ACS Textiles (Bangladesh) Ltd. (Extension)

Tetlabo, Barpa, Rupgonj, Narayangonj.

10 March 2024

2. Observations

Observation-1: Marginal stress in column exceeds normal design limit (Digital Printing building).

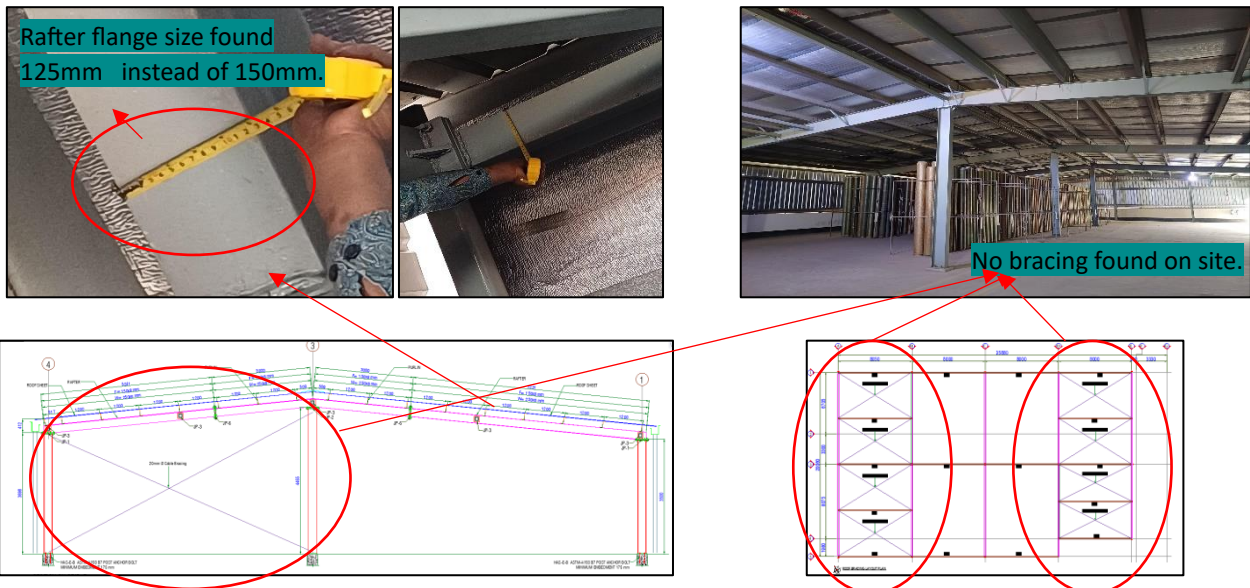
Description: The cursory calculation indicates that stress in the marked column exceeds the normal design limit considering the floor live load of 3 kPa for the typical floor & 6 kPa for the storage area and concrete strength of 17.4 MPa. The building engineer is required to review the design, loads, and column stresses for the marked columns based on in-situ material strength. The building engineer is also required to Produce and actively manage a loading plan for all floor plates within the factory considering floor capacity and column capacity.

Observation-3: Storage live load limit does not comply with BNBC requirement (Digital Printing building).

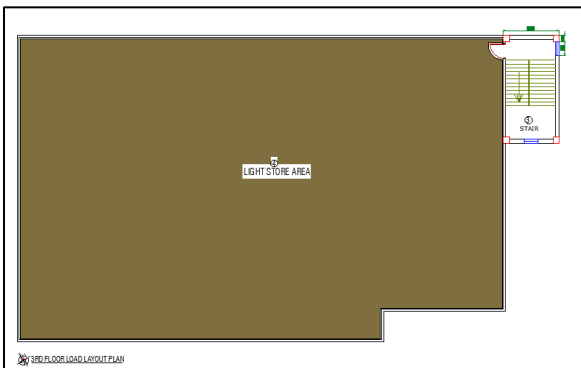
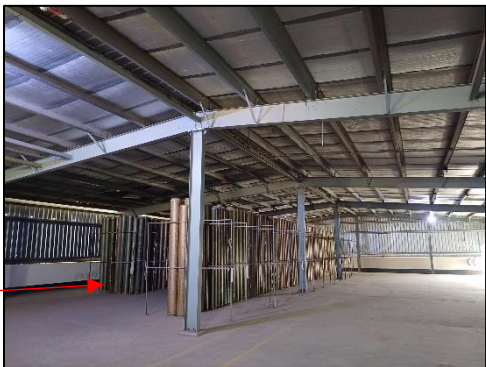
Description: As per BNBC, 6 kPa is required to be considered as floor loading for the light storage facilities. During the inspection, the load plan was found considering (63 psf) 3kPa at the 3rd floor (roof shed) storage area. However, the building engineer is required to update the storage live load limit as per BNBC requirements and revise the structural analysis & design accordingly.

Observation-4: Lack of lateral stability of adjacent steel stairs (Digital Printing building).

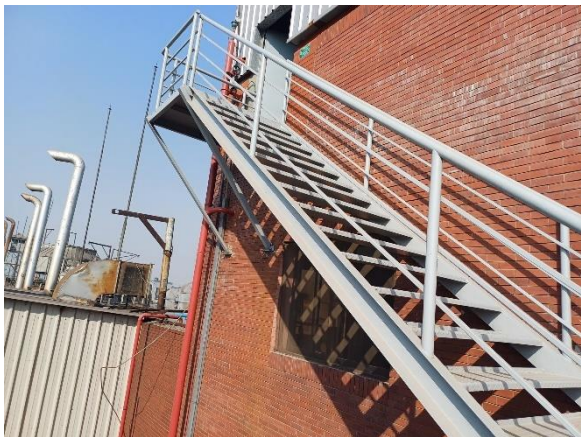
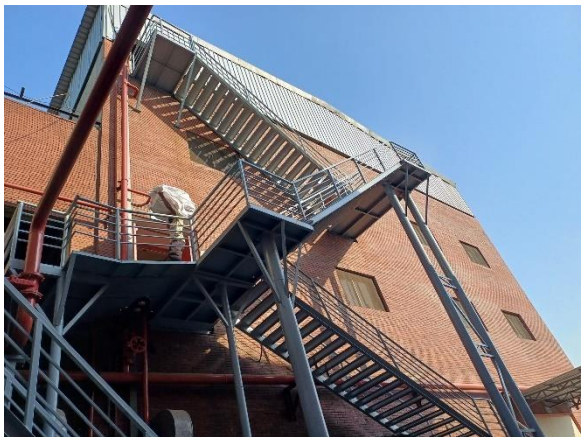
Description: The steel stair appeared to be unstable due to a lack of lateral load transfer media. The building engineer is required to check the lateral stability of the steel stair, perform an Engineering assessment (EA) and suggest remediation if required.

Observation-5: Marginal stress in column exceeds normal design limit (Weaving Building 4).

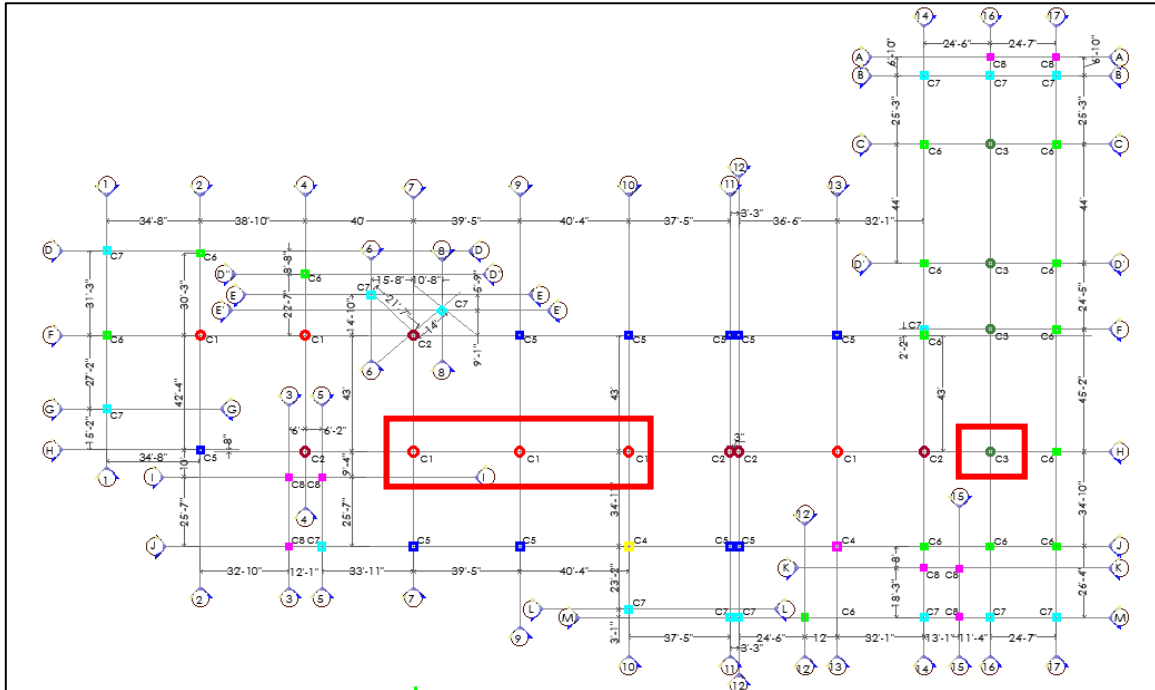
Description: The cursory calculation indicates that stress in the marked column exceeds the normal design limit considering the floor live load of 6 kPa for the storage area & typical floor and concrete strength of 18.4 MPa. The building engineer is required to review the design, loads, and column stresses for the marked columns based on in-situ material strength. The building engineer is also required to Produce and actively manage a loading plan for all floor plates within the factory considering floor capacity and column capacity.

Observation-6: Storage live load limit does not comply with BNBC requirement (Weaving Building 4)

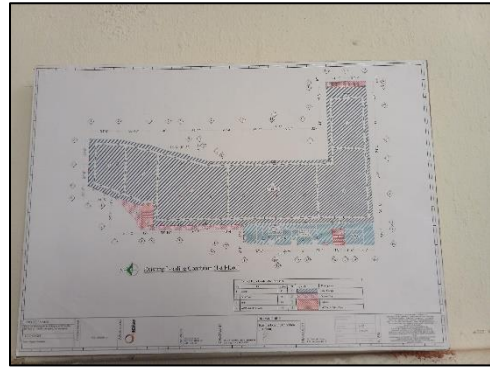
Description: As per BNBC, 6 kPa is required to be considered as floor loading for the light storage facilities. During the inspection, the load plan was found considering (63 psf) 3kPa at the 3rd floor (roof shed) storage area. However, the building engineer is required to update the storage live load limit as per BNBC requirements, and revise the structural analysis & design accordingly.

Observation-11: Mismatch in as built drawings - Sizing-3 (Re-Coning building).

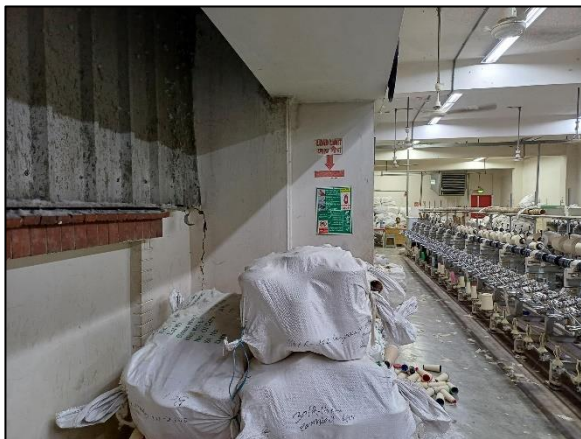
Description: During inspection, a grid mismatch was found in the as-built drawings. The building engineer is required to survey the whole structure, update the as-built drawings, perform an Engineering Assessment (EA) and submit it to RSC for review.

Observation-13: Design documents need to be reviewed by RSC for lateral forces - Dryer shed (washing units).

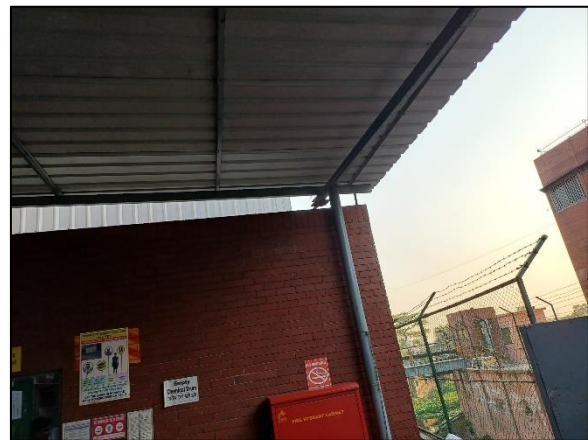
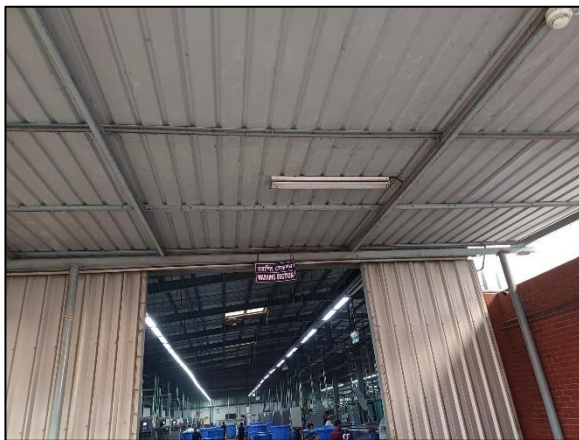
Description: During the inspection, a design report and as-built drawings were available on site which need to be reviewed by RSC in depth for lateral forces. The building engineer is required to submit the design documents to RSC for review and implement remedial works If required.
